Fiber emulator filter proposal for 1060nm PMD

In support of comment #130 on .3ds Draft 1.1

Roberto Rodes, Coherent

Total channel 3dB_e bandwidth vs wavelength for 850 nm VCSELs at 106.25 GBd

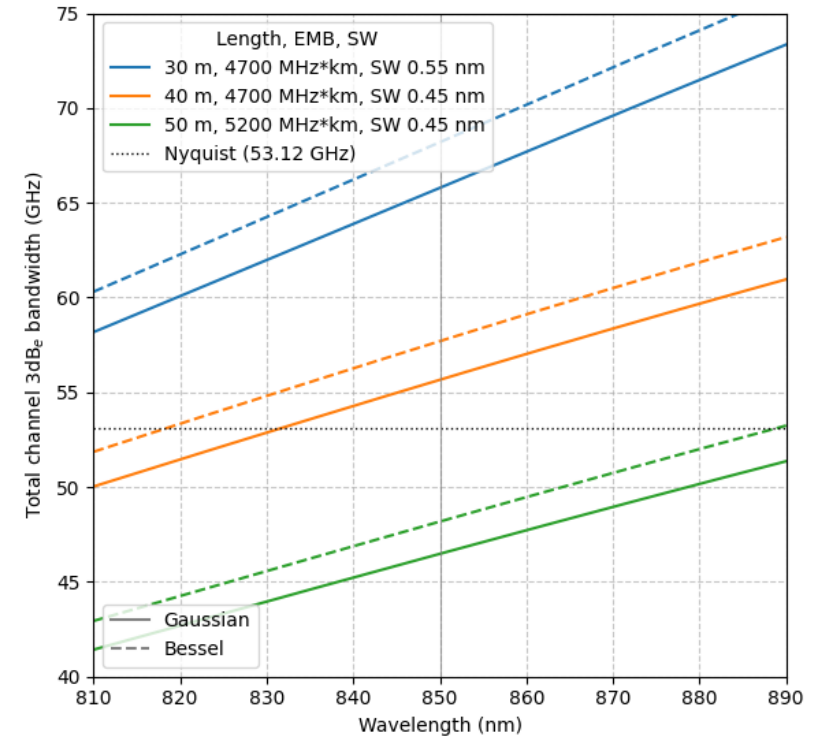
Fiber emulator filter 3dB BW at 850nm:

SR-30 (spectral width = 0.55 nm):

30m OM4, 4700 MHz*km -> Gaussian: 65.76 GHz, Bessel: 68.17 GHz

SR-50 (spectral width = 0.45 nm):

40 m OM4, 4700 MHz*km -> Gaussian: 55.63 GHz, Bessel: 57.67 GHz

50 m OMz, 5200 MHz*km -> Gaussian: 46.45 GHz, Bessel: 48.15 GHz

Total channel 3dB_e bandwidth vs wavelength at 106.25 GBd with a spectral width of 0.50 nm

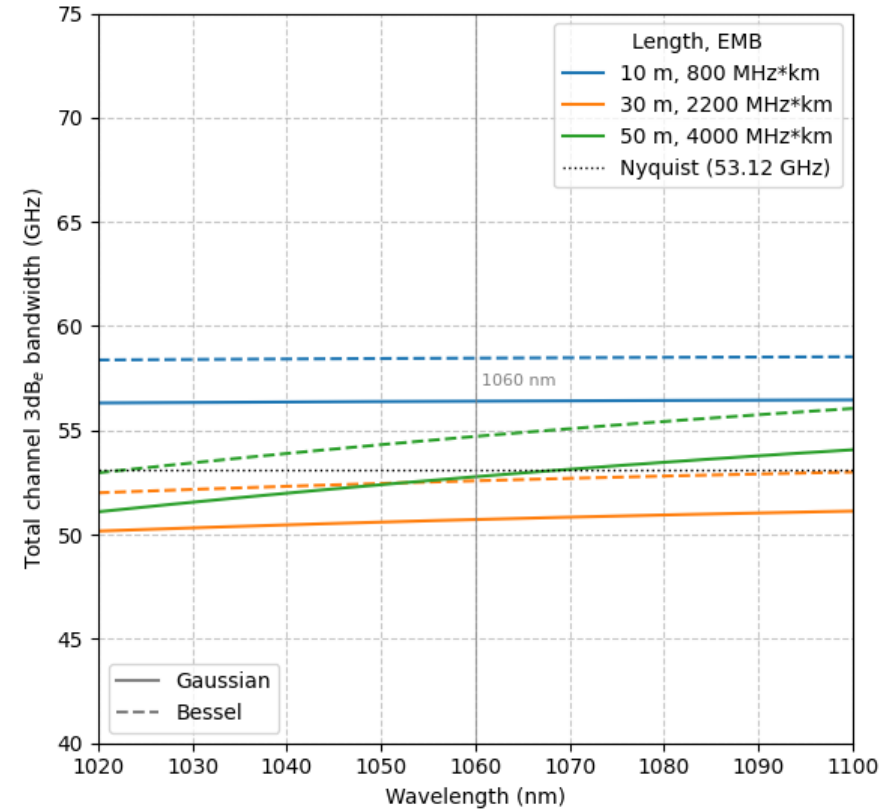
Cl 194	SC 194.9.7	P106	L36	# 130
Rodes, Roberto		Coherent		
Comment Type T		Comment Status X		
3dB bandwidth of the fiber emulator filter is currently TBD				
<i>Suggested Remedy</i>				
Change TBD with 52.6GHz. Contribution justifying the value will be presented

Total channel 3dB_e bandwidth at 1060 nm (spectral width = 0.50 nm):
 10 m, 800 MHz*km -> Gaussian: 56.40 GHz | Bessel: 58.47 GHz
 30 m, 2200 MHz*km -> Gaussian: 50.72 GHz | **Bessel: 52.58 GHz**
 50 m, 4000 MHz*km -> Gaussian: 52.77 GHz | Bessel: 54.70 GHz

- Replace the TBD value for the 3 dB bandwidth of the fiber emulator filter used for TDECQ measurement in Table 194-14 with **52.6 GHz**.
